## SERVICE BULLETIN

REFERENCE TRANSMISSION & CLUTCH  
 NUMBER 034  
 DATE 08-24-90  
 MODEL AE9#, EL3#, AW1#, ST6#, SV2#

### OIL STRAINER & ACCUMULATOR TUBES A13#, A14#, A24# DESIGN CHANGE

1. A131L, A132L A/TM

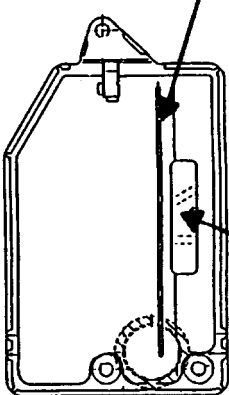
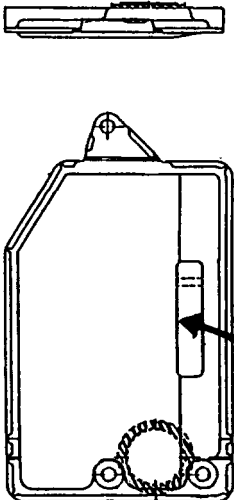
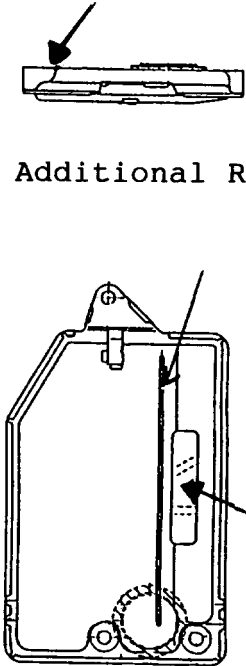
The oil strainer mesh and shape of the strainer have been changed. The brake and clutch accumulator tubes have been changed to accommodate the modified oil strainer (refer to illustrations for modifications).

PART NAME	PREVIOUS	NEW
Tube, Rear Clutch Accumulator		
Tube, Brake Accumulator		
Strainer Assy, Oil	 <p data-bbox="850 1688 927 1745">#120 Mesh</p>	<p data-bbox="1032 1247 1300 1339">Modified Shape (Only P/N 35330-20012)</p>  <p data-bbox="1036 1472 1308 1499">Additional Rib</p> <p data-bbox="1344 1692 1425 1749">#200 Mesh</p>

2. A140L A/TM

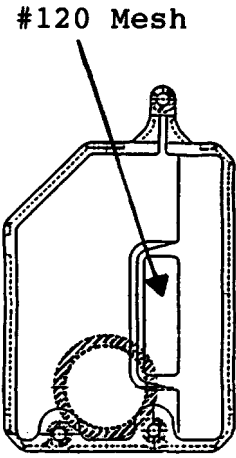
PART NAME	PREVIOUS	NEW
Tube, Rear Clutch Accumulator		
Tube, Brake Accumulator		
Strainer Assy. Oil	<p style="text-align: center;">Modified Shape</p> <p style="text-align: center;"></p> <p style="text-align: center;">Additional Rib</p> <p style="text-align: center;"></p> <p style="text-align: right;">#120 Mesh</p>	<p style="text-align: center;">Modified Shape</p> <p style="text-align: center;"></p> <p style="text-align: center;">Additional Rib</p> <p style="text-align: center;"></p> <p style="text-align: right;">#200 Mesh</p>

### 3. A140E A/TM

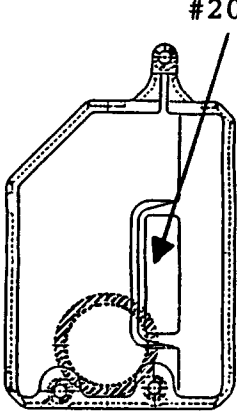
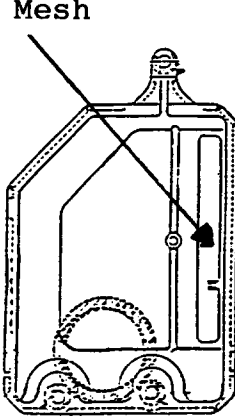
PART NAME	PREVIOUS	NEW
Tube, Rear Clutch Accumulator		
Tube, Brake Accumulator		
Strainer Assy. Oil	 <p style="text-align: right;">#120 Mesh</p>	<p>Modified Shape</p>  <p>Additional Rib</p> <p style="text-align: right;">#200 Mesh</p>
